**Western Star
Service Bulletin**

General Information

Fig. 1, Position of Pilot Bearing When Spacer Is Not Needed

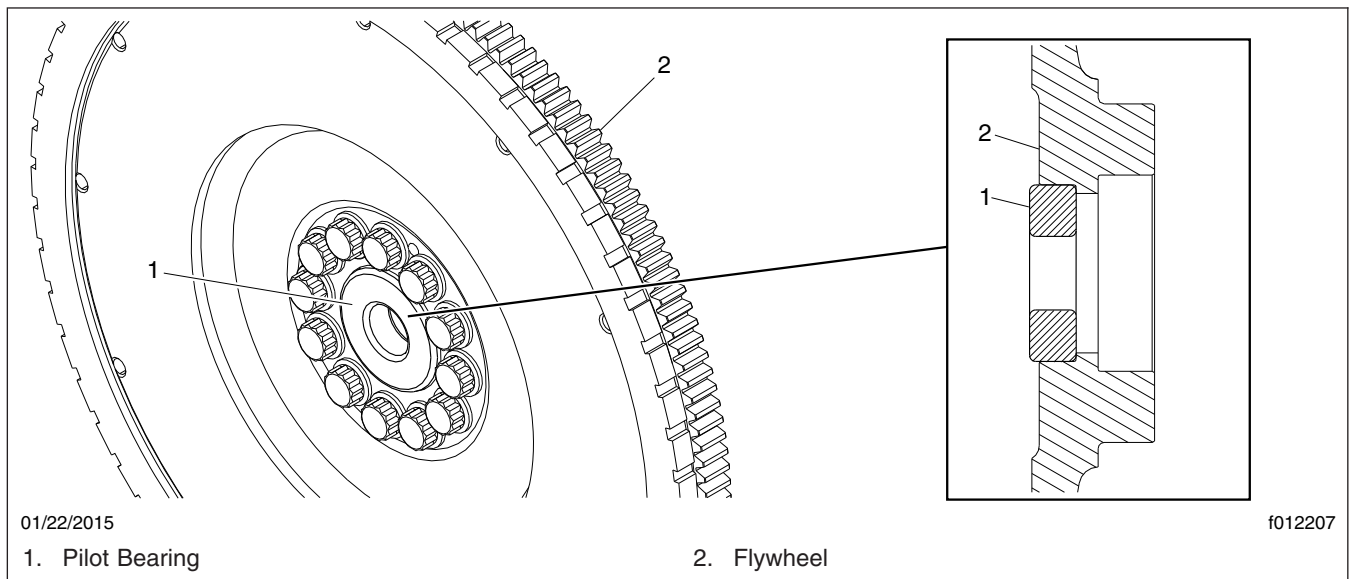
On vehicles that do not have a pilot bearing spacer installed, the pilot bearing will be flush with the flywheel. On vehicles that already have the spacer, the bearing will protrude approximately 1/4 inch from the flywheel, as shown in [Figure 1](#).

A spacer, part number 02-14069-000, is now available to reposition the pilot bearing within the flywheel by the same amount as the revised flywheel.
